Rezoning Transportation Analysis

Petition Number: 2026-004

Date	Description
3-26-26	First Review (IW)

CLDSM standard U-07A

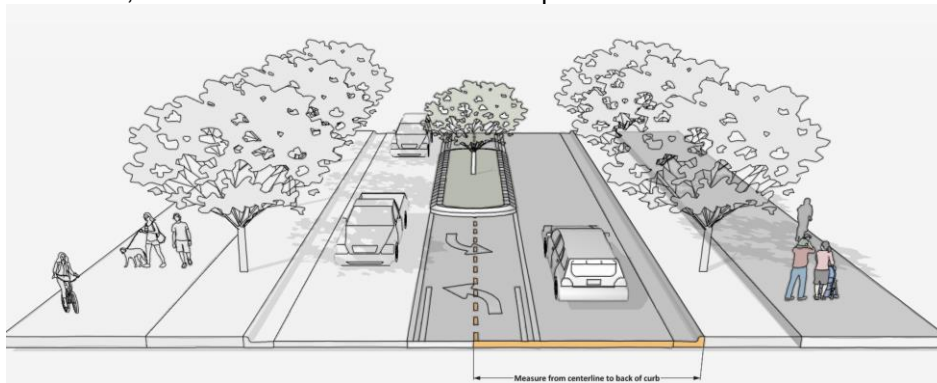
- a. **Oak Drive:** Location of future back of curb and gutter is 17.5 feet from centerline.

Label and dimension the curb and gutter from the centerline for each road on the site plan to be referenced only.

- b. **Oakdale Road:** The future location of curb and gutter is in its existing location.

2+ Avenue, Shared Use Path from Streets Map

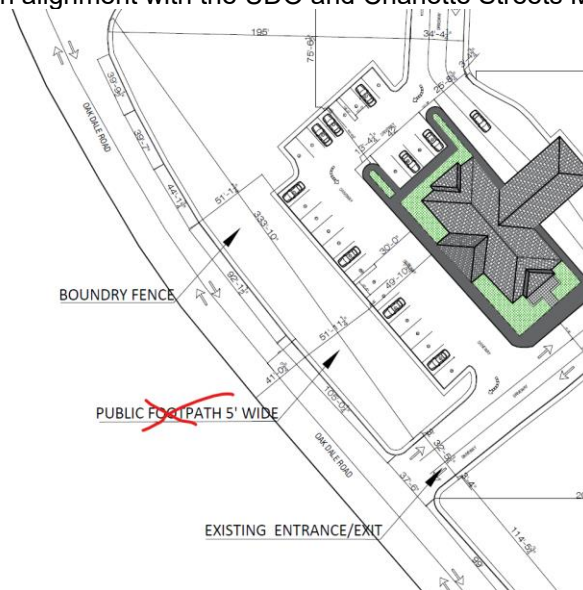
Label and dimension the curb and gutter from the centerline for each road on the site plan.
